**East Bay Park Improvements
Bobby Alford Pavilion
Project #1232 – CDBG #CV1-019
Request for Bid (RFB)
Date: February 24, 2023**

ADDENDUM II

ATTACHMENT A
TO ADDENDUM 02

ELECTRICAL PLAN - LIGHTING

E-201

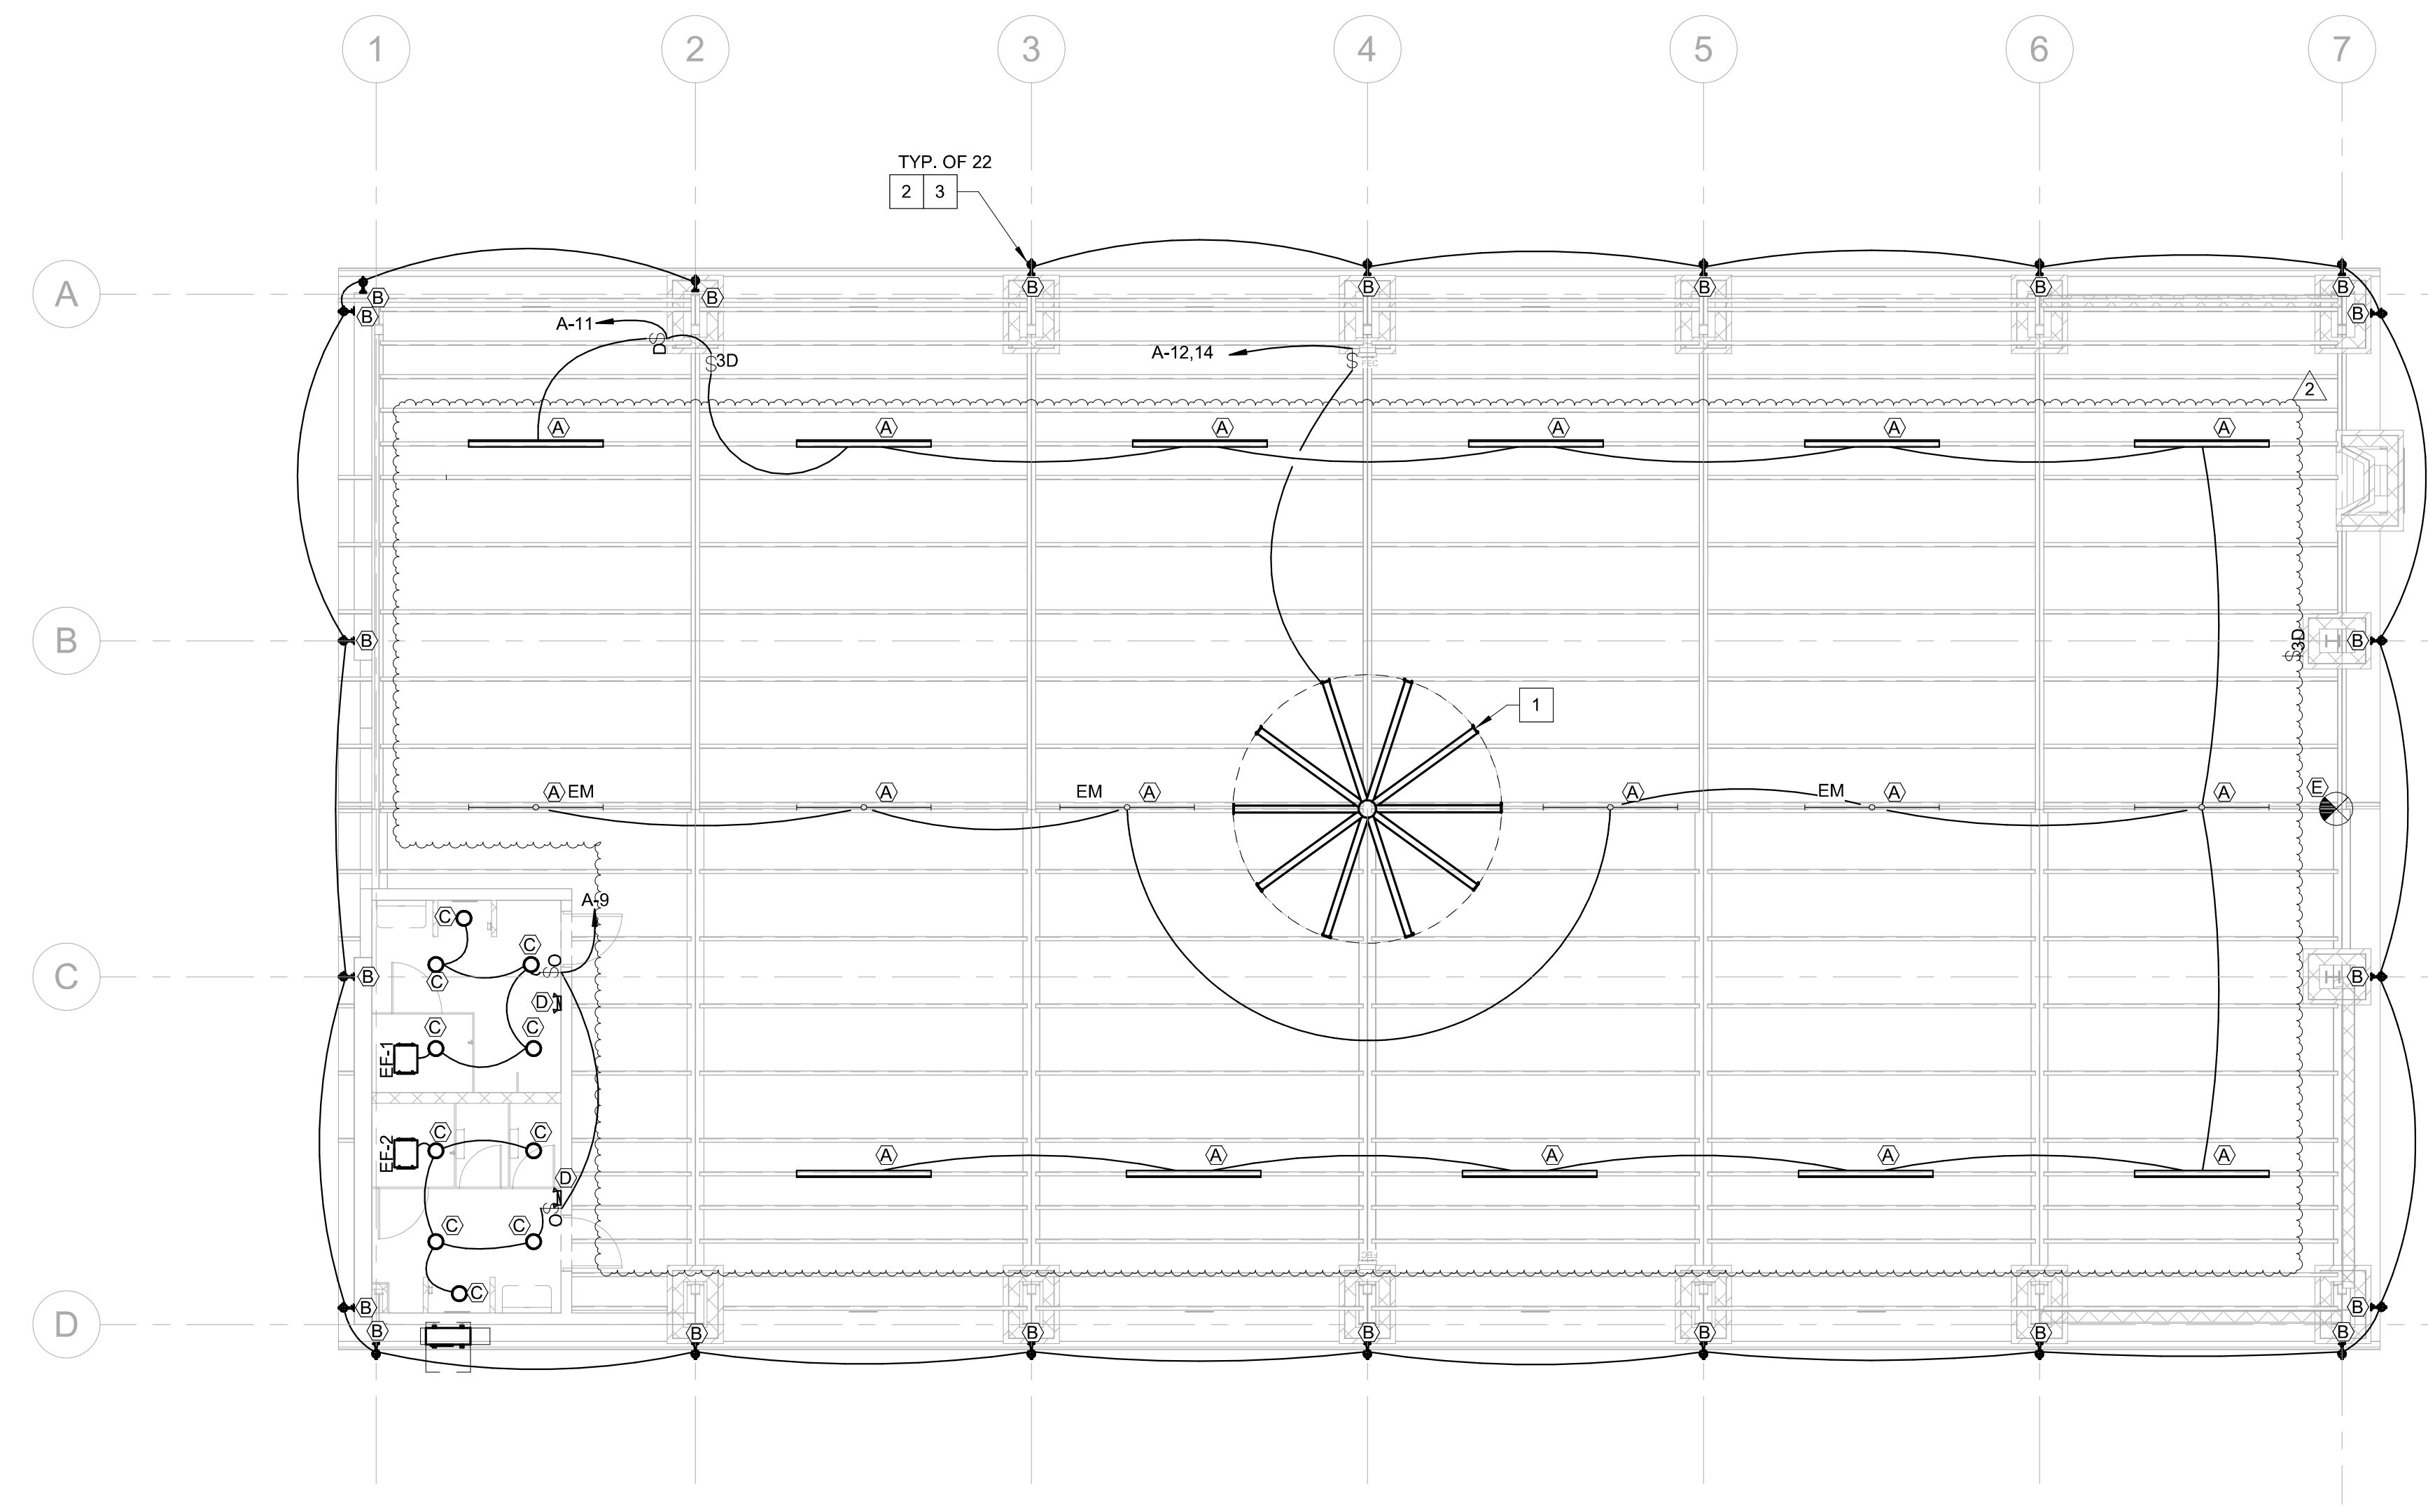
1. **Sheet E-201 - Electrical Plan - Lighting** - See clouded revisions per Attachment A to Addendum 02. Revisions include:

- a. Light Fixture Schedule: Change Type 'A' strip light fixture from pendant-mounted to surface-mounted to underside of roof purlins, and revision to catalogue #.
- b. Lighting Plan: Revise orientation of Type 'A' fixtures from perpendicular to roof purlins to parallel with purlins.
